NATURAL RESOURCE DAMAGE PROGRAM

August 4, 2023

Re: State of Montana Natural Resource Damage Program Comments on June 28, 2023, Blacktail Creek PDI Work Plan and Project

Figure BTC-1
 Blacktail Creek
 Remedial Action Plan

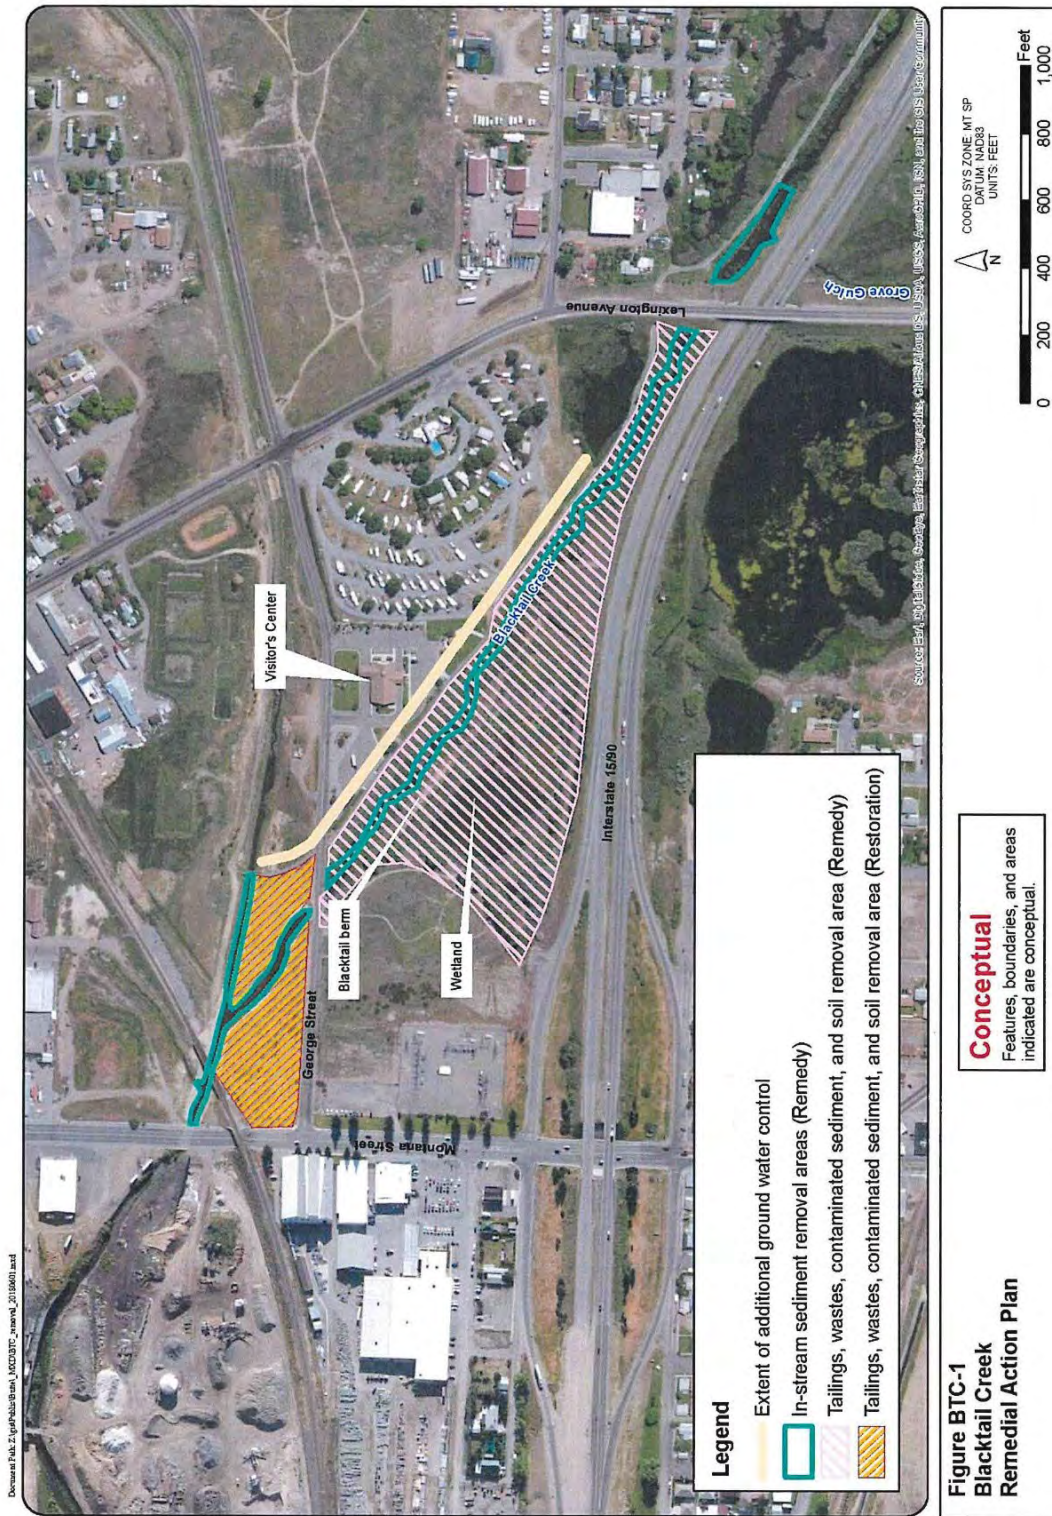
The BTC groundwater capture system that BP-AR is required to construct should be fully functional prior to the State's construction of the BTC Riparian Actions (Attachment B). If the BTC Riparian Actions are constructed prior to this groundwater control, contaminated groundwater could recontaminate the instream sediments. BP-AR has recently acknowledged this sequencing necessity in its latest schedule, as is required by Exhibit 1 to Appendix D of the BPSOU CD. We thought it prudent to restate it here.

Attachment C

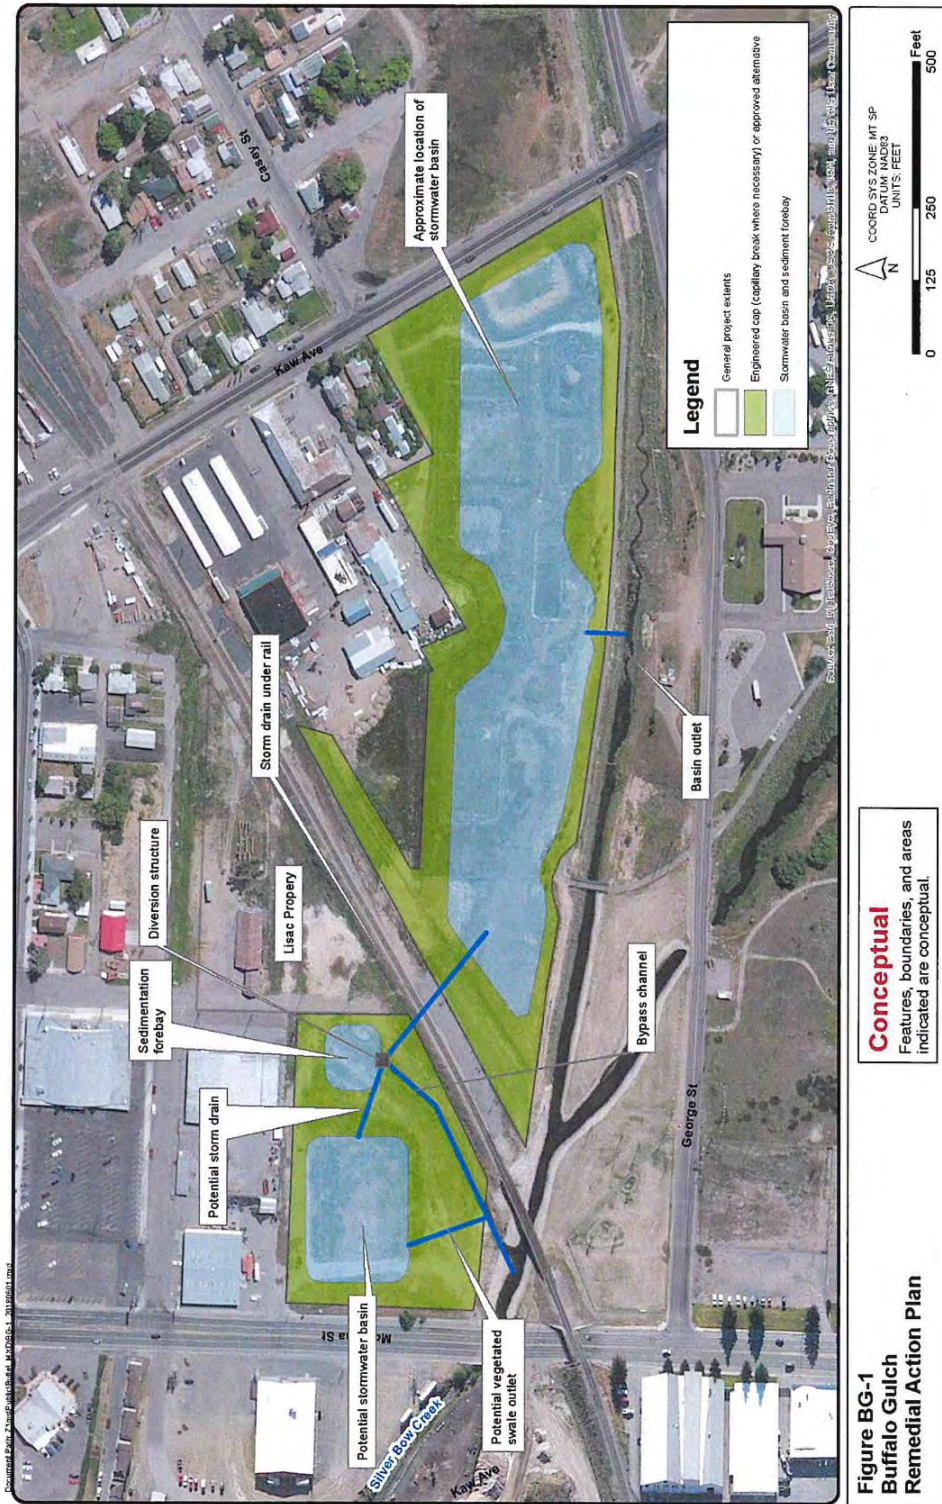
It is clear from the attached figures that the Digging East Stormwater Basin (DESB) (Attachment D) and Buffalo Gulch Stormwater Basin (Attachment C) will both need to be constructed and functioning prior to the State's BTC Riparian Actions work. Without these capture and treatment systems in place, contaminated sediments would continue to be transported by Silver Bow Creek above the confluence to the BTC Site, specifically the confluence area. Clearly, as in other cases,
